ERRATA SHEET

Report Number: NUREG/CR-3071
PNL-4543

Report Title: Irradiation History and Interim Postirradiation
Data for IFA-432

Subject: Errata for Appendix D

FIGURE 1.

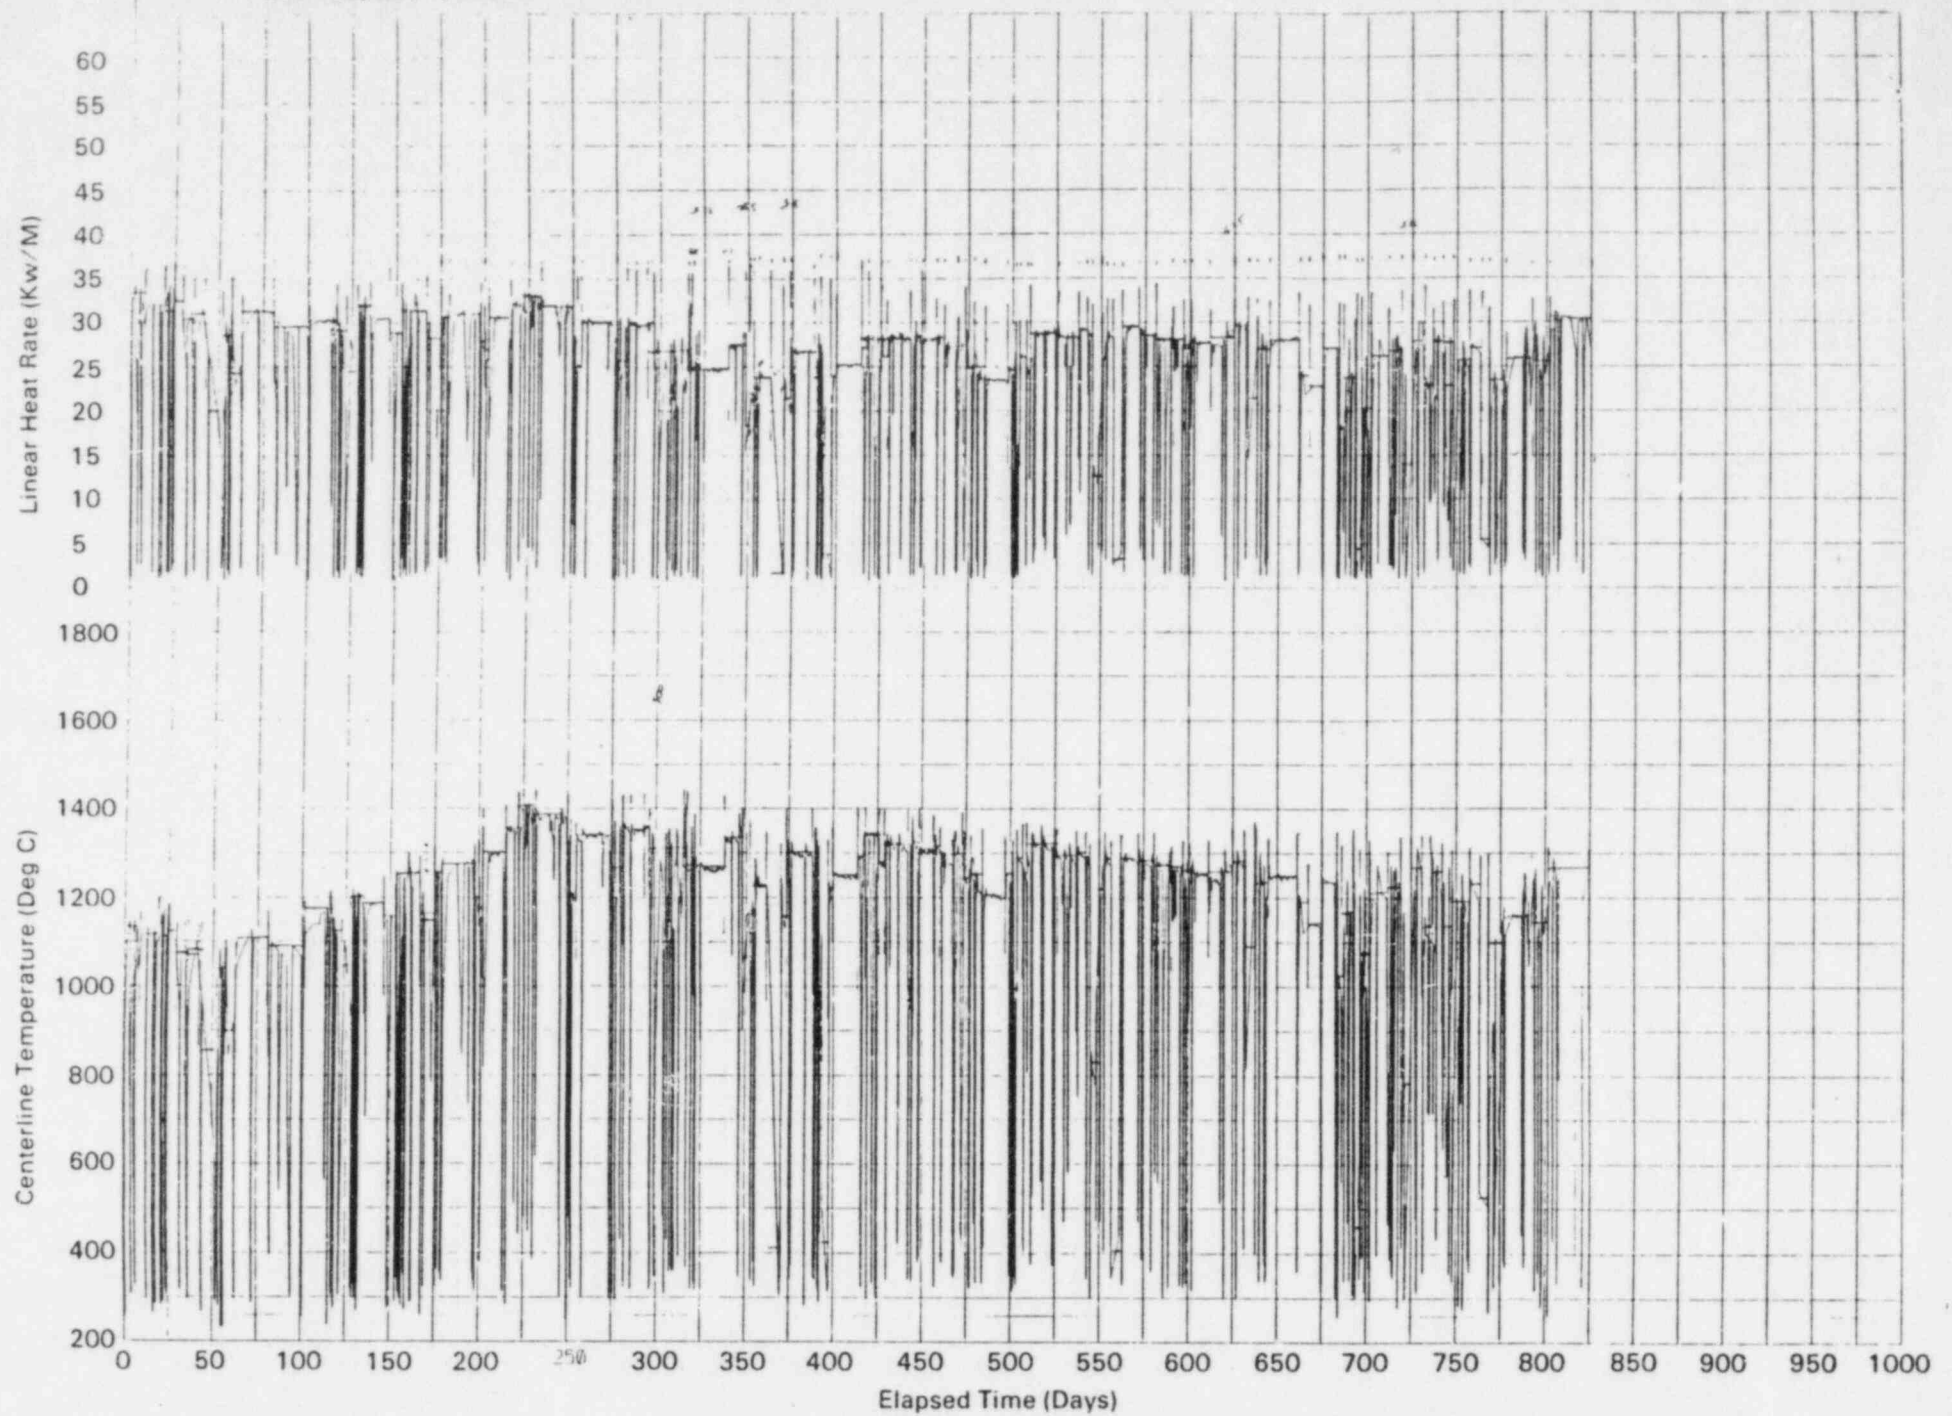
Note that no other manipulation of the published values for linear heat generation rate (LHGR) are recommended at this time. To emphasize the connection between the tabulated LHGR values and the actual power history we are attaching Figures 1 and 2, in which the lower and upper thermocouple region LHGRs are plotted for Rod 1.
